Project	IEEE 802.16 Broadband Wireless Access Working Group http://ieee802.org/16 >	
Title	MBS service by application signaling between MS and network	
Date Submitted	2008-03-10	
Source(s)	Jaejeong(Brian) Shim, Yeongmoon Son	Voice: E-mail: brian.shim@samsung.com
	KiBack Kim Samsung Electronics*	* <http: affiliationfaq.html="" faqs="" standards.ieee.org=""></http:>
Re:	LB26b	
Abstract	This contribution proposed an optional way of MBS setup operation using application signaling between MS and network.	
Purpose	Accept the proposed specification changes on IEEE P802.16Rev2/D3.	
Notice	This document does not represent the agreed views of the IEEE 802.16 Working Group or any of its subgroups. It represents only the views of the participants listed in the "Source(s)" field above. It is offered as a basis for discussion. It is not binding on the contributor(s), who reserve(s) the right to add, amend or withdraw material contained herein.

MBS service by application signaling between MS and network

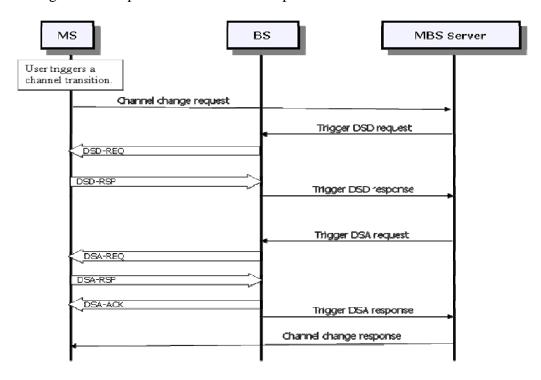
MBS content channel transition time during switching b/w broadcast channels

- Incurred by DSx transactions
 - DSD for an existing MBS channel
 - DSA for a new MBS channel
- · Waste of air resource by frequent channel transitions by users
- The following is an example of channel transition procedure.
